**New Albany Architectural Review Board Meeting Agenda**  
Monday, February 12, 2024 7:00 p.m.

**ARB-001-2024 Certificate of Appropriateness with Waivers**

Certificate of Appropriateness to construct a new daycare to be located generally at the southwest corner of Main Street and Miller (PID: 222-000019, 222-000219, 222-000030). **Applicant: J. Carter Bean Architect LLC**

LOCATION: Generally located at the southwest corner of Main Street and Miller Avenue  
(PIDs: 222-000019, 222-000219, 222-000030)  
APPLICANT: J. Carter Bean Architect LLC  
REQUEST: Certificate of Appropriateness & Waivers  
ZONING: Urban Center District within the Village Core Sub-District  
STRATEGIC PLAN: Village Center  
APPLICATION: ARB-01-2024

SITE LANDSCAPE PLAN

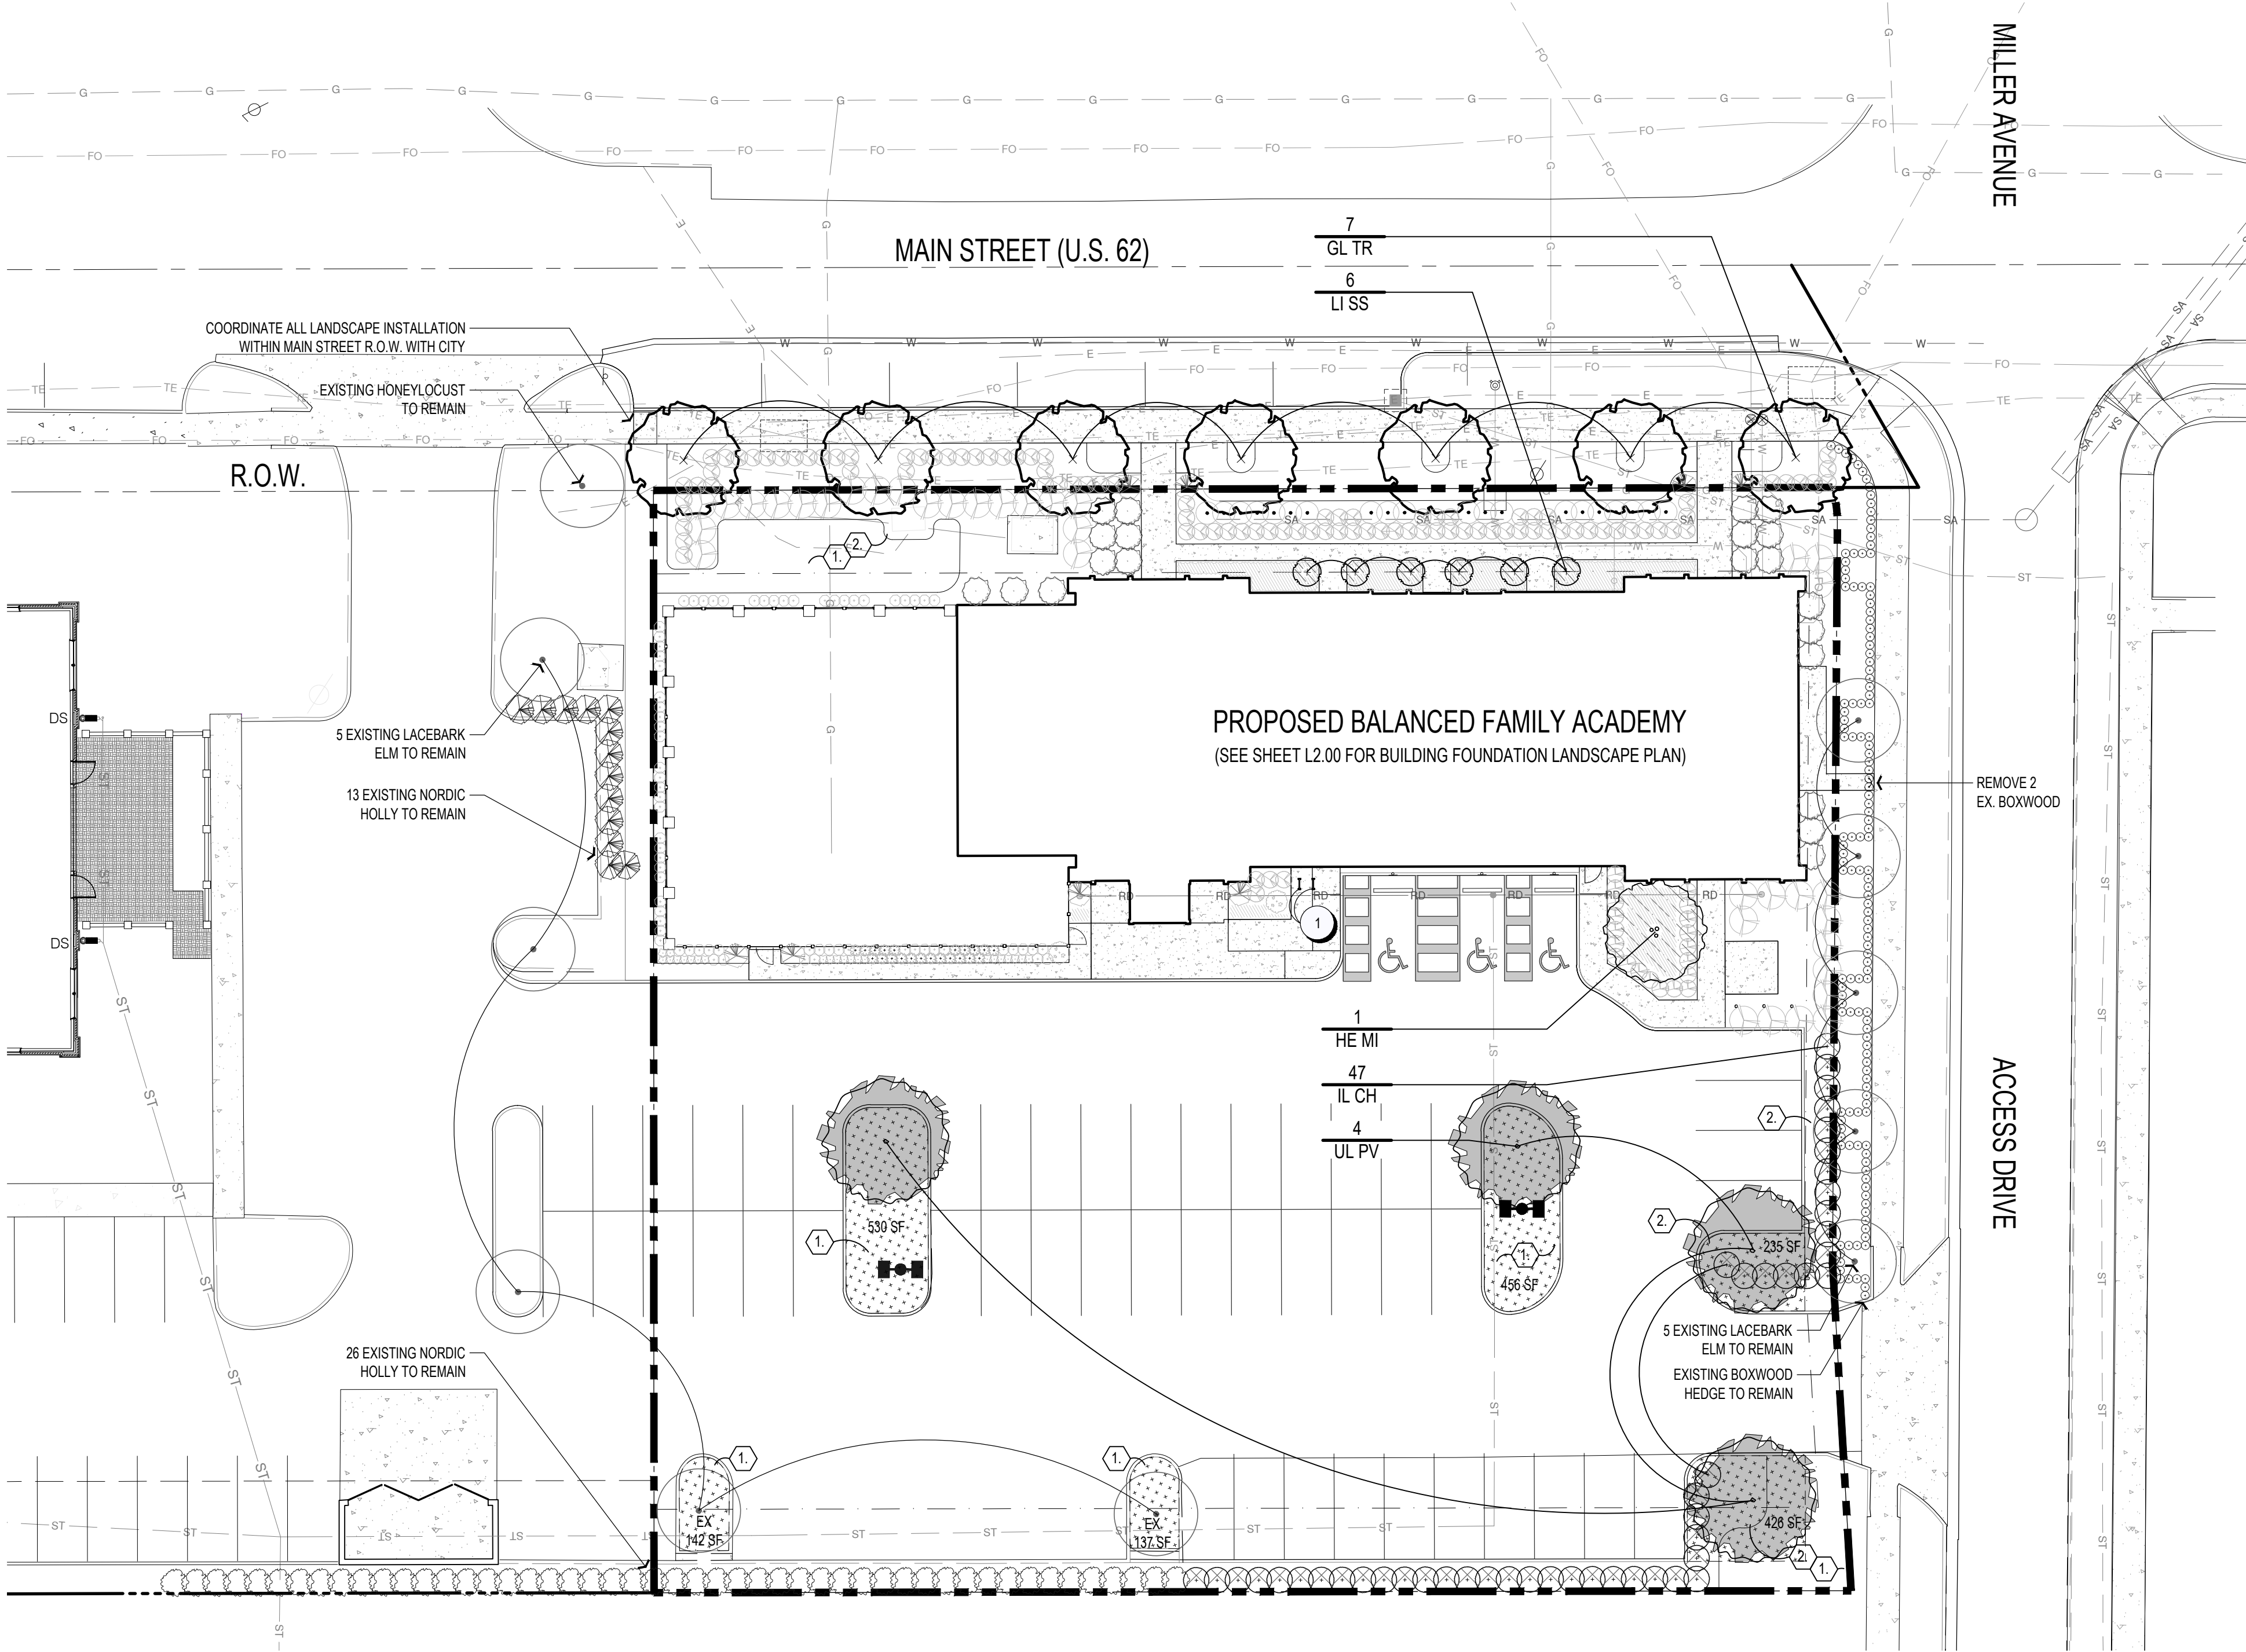
- Parking areas should contain a minimum of one deciduous canopy tree for every ten parking spaces. The landscape plan states they are adding an additional 40 spaces to the existing spaces, therefore requiring 4 trees. However, the requirement is based on the total 55 spaces provided on site.

- The landscape plan meets this standard.
- The city landscape code requires street trees to be installed. Street trees are typically installed 30 feet on center, shall be a minimum of three (3) inches caliper, and must be of the same genus and species planted continuously along the length of each street.

4 SOUTH EXTERIOR ELEVATION  
1/8" = 1'-0"

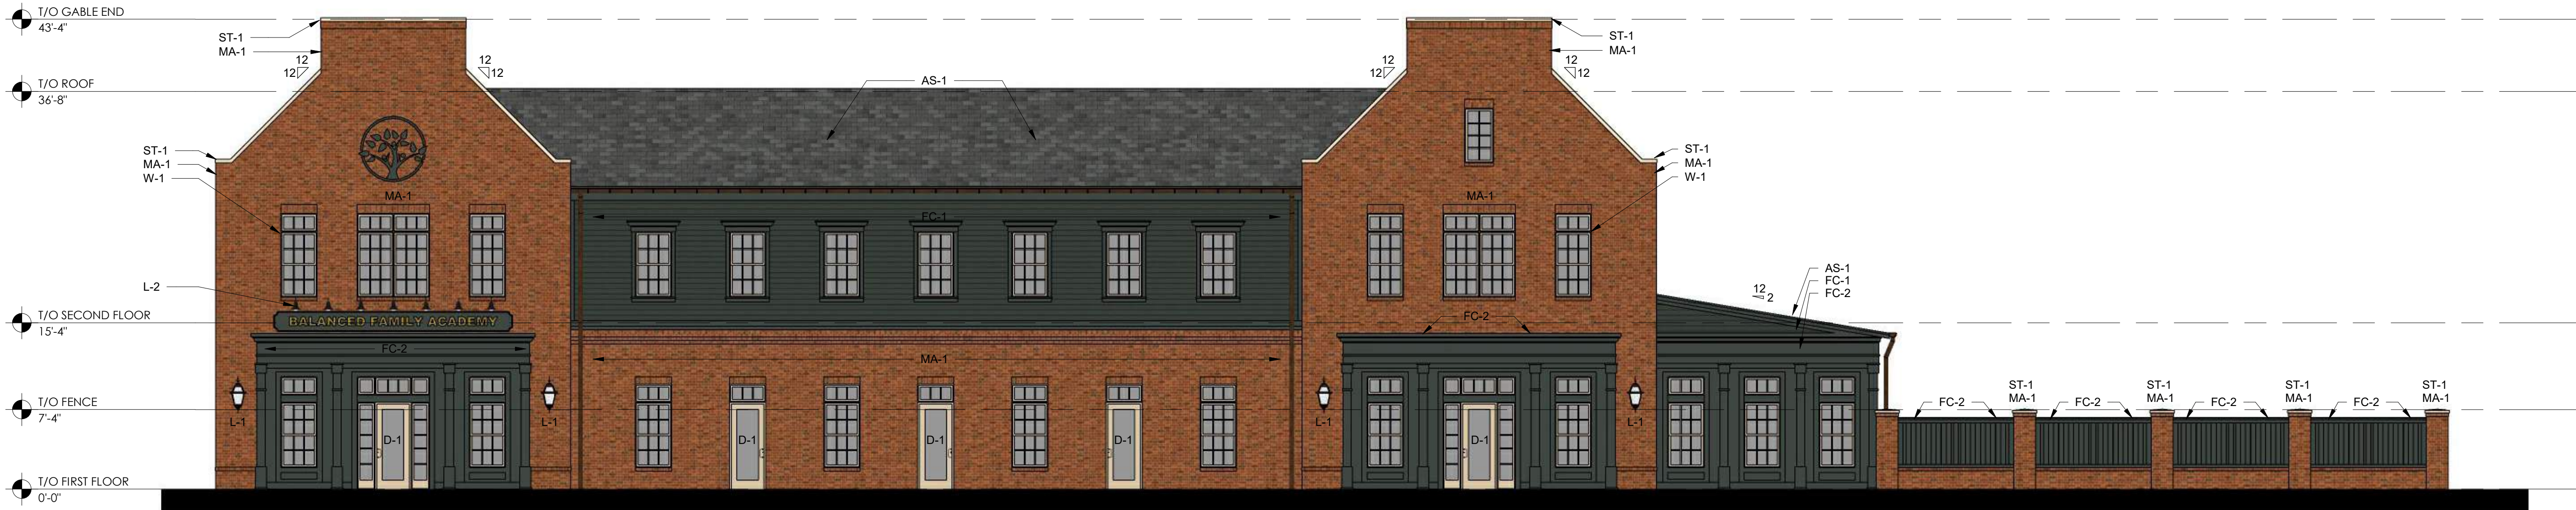
- The architecture meets this standard as the majority of the building is brick.
- The exterior material of the building also includes sections of hardi-plank siding. DGR Section 3 (II.E.1 and II.E.2) states the uses of façade materials other than wood or brick must be approved by the Architectural Review Board. The use of alternate materials such as hardi-plank may be appropriate when they are used in the same way as traditional materials would have been used.

- The Architectural Review Board should review and evaluate the appropriateness of the proposed hardi-plank material to ensure it is used in the same way as traditional materials (wood).
